**SOLICITATION AMENDMENT
MODIFICATION DE L'INVITATION**

Title - Sujet Sudbury Mail Processing Room	
Solicitation No. - N° de l'invitation EQ754-180699/A	Amendment No. - N° modif. 002
Client Reference No. - N° de référence du client EQ754-180699	Date 2017-07-27
GETS Reference No. - N° de référence de SEAG	
File No. - N° de dossier PWL-7-40035 (003)	CCC No./N° CCC - FMS No./N° VME
Solicitation Closes - L'invitation prend fin at - à 02:00 PM on - le 2017-08-10	
Time Zone Fuseau horaire Eastern Daylight Saving Time EDT	
F.O.B. - F.A.B. Plant-Usine: <input type="checkbox"/> Destination: <input checked="" type="checkbox"/> Other-Autre: <input type="checkbox"/>	
Address Enquiries to: - Adresser toutes questions à: Dhanna, Sheila	Buyer Id - Id de l'acheteur pwl003
Telephone No. - N° de téléphone (416) 512-5855 ()	FAX No. - N° de FAX (416) 512-5862
Destination - of Goods, Services, and Construction: Destination - des biens, services et construction: CRA 1050 Notre Dame Ave Sudbury, ON X1X 1X1 Canada

Project title: SUDBURY, ONTARIO
CANADA REVENUE AGENCY
1050 NOTRE DAME AVE.

ADDENDUM-01

Drawing no: AD1-SK01

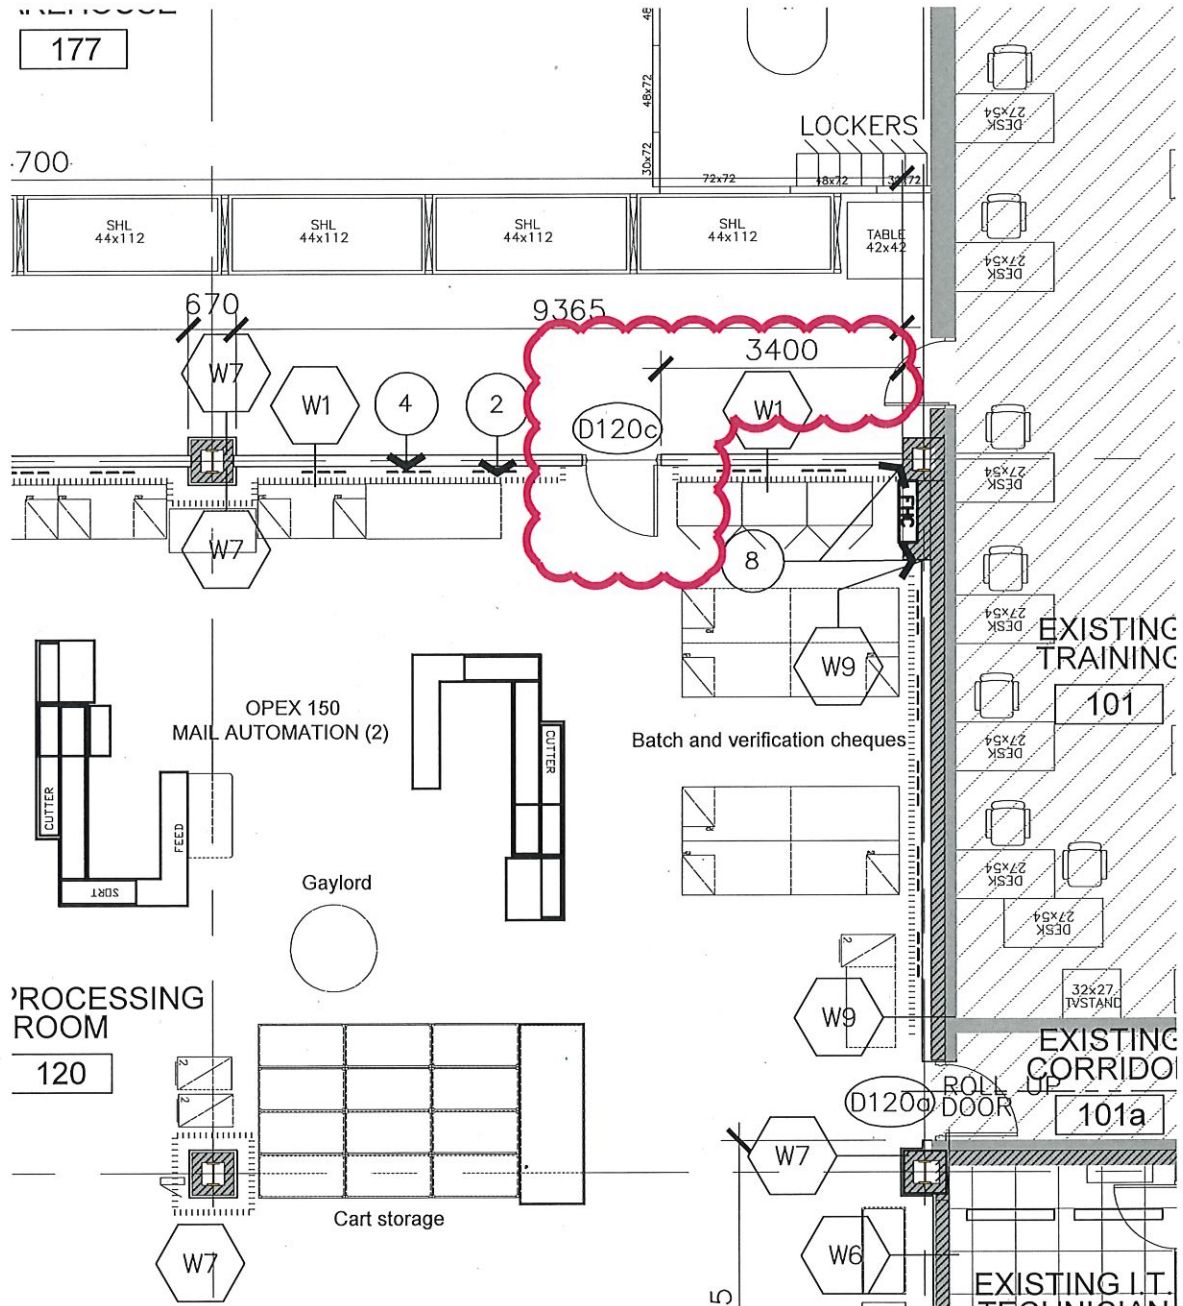
1.1 Drawing 1/A1 Revised Level 1 - New Construction Plan:

Add door 120C as indicated.

Modify layout of low level wall protection trolley rail in coordination with door location.

Omit requirement for (2) acoustic wall panels located in front of door.
Redistribute acoustic wall panel layout between door and existing column E-6

Refer to attached AD1-SK01
